S.R. 0001 Section RC3 Preliminary Engineering Noise Report Addendum Memo April 2025

The Pennsylvania Department of Transportation (PennDOT) has advanced the S.R. 0001 Section RC3 project, located in Middletown Township, Langhorne, and Langhorne Manor Boroughs, PA, through the preliminary engineering design phase. The Preliminary Engineering Noise Report was approved by the Federal Highway Administration (FHWA) on November 8, 2022 (the concurrence Memo is included with this Memorandum).

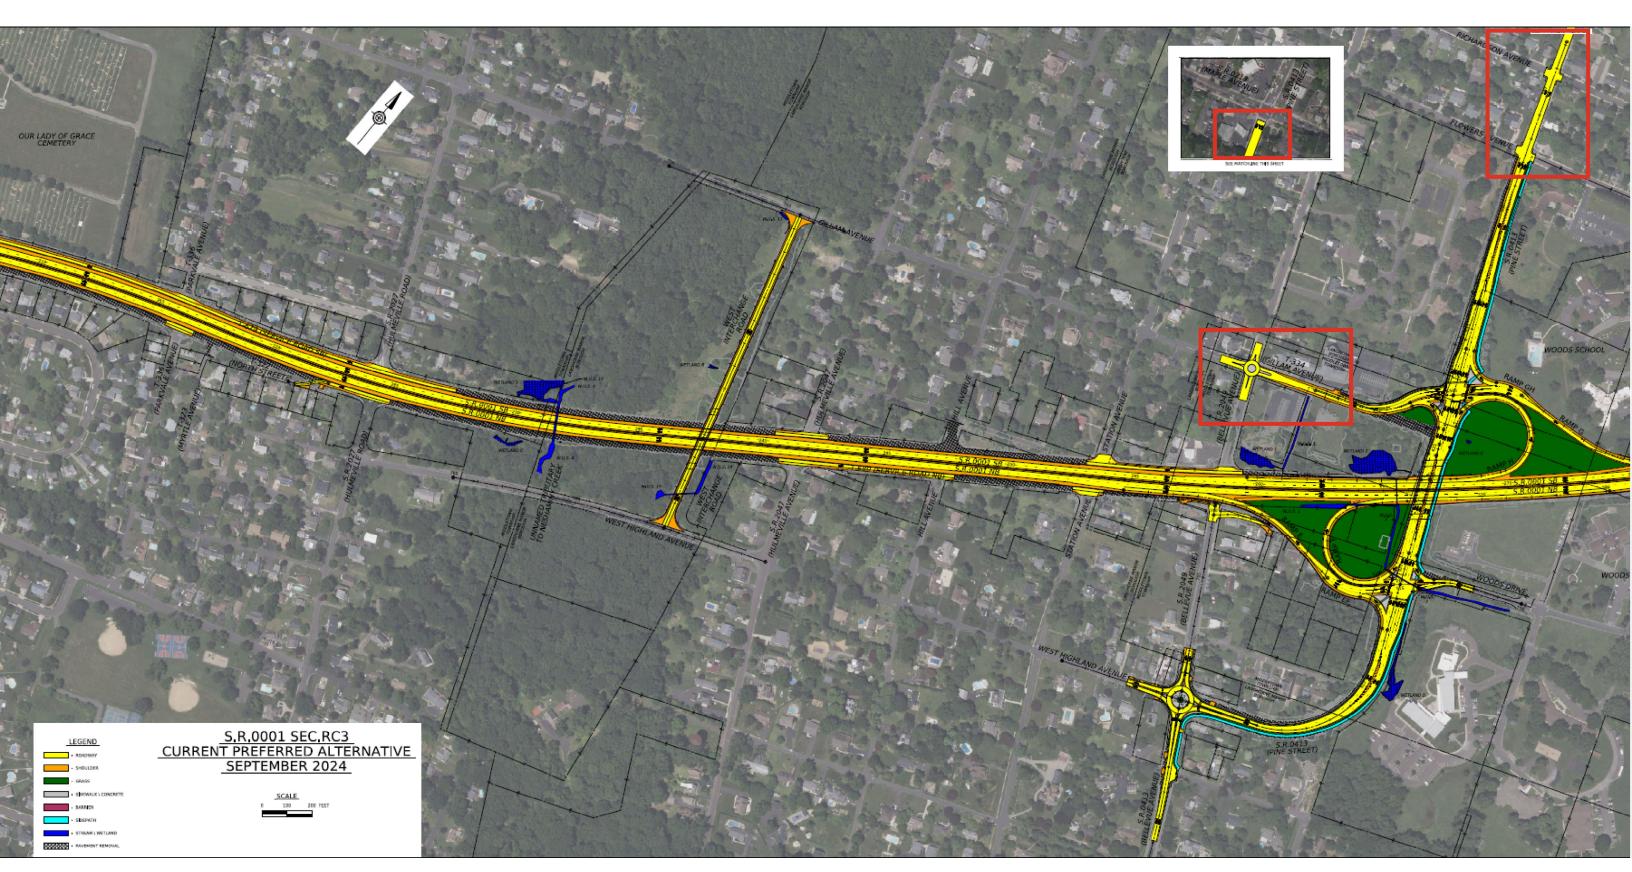
The proposed interim changes to the design include:

- The introduction of a mini roundabout at the Bellevue Avenue/Gillam Avenue intersection (intended to serve as a traffic calming measure).
- The extension of project limits approximately 900' north along SR 413 (North Pine Street) to incorporate minor changes to the local roadway design. The limits previously terminated south of the SR 413/Flowers Avenue intersection, but now extend to the SR 413/Maple Avenue intersection.

These areas where changes occur can be found on the attached break-out graphic from the design engineering team's September 2024 Roll Plot. The areas of proposed change have been outlined in red. No other acoustically significant changes have been identified.

The proposed changes have no effect on the 2022 Preliminary Engineering Noise Report abatement recommendations, as any potential impacts at these locations would be due to the local roadway network. It is not possible to design effective abatement (an unbroken vertical noise barrier) for potential impacts on these local roadways and still maintain vehicular and pedestrian access. Therefore, noise abatement for these locations would not be feasible (if even warranted), and therefore would not be proposed for construction.
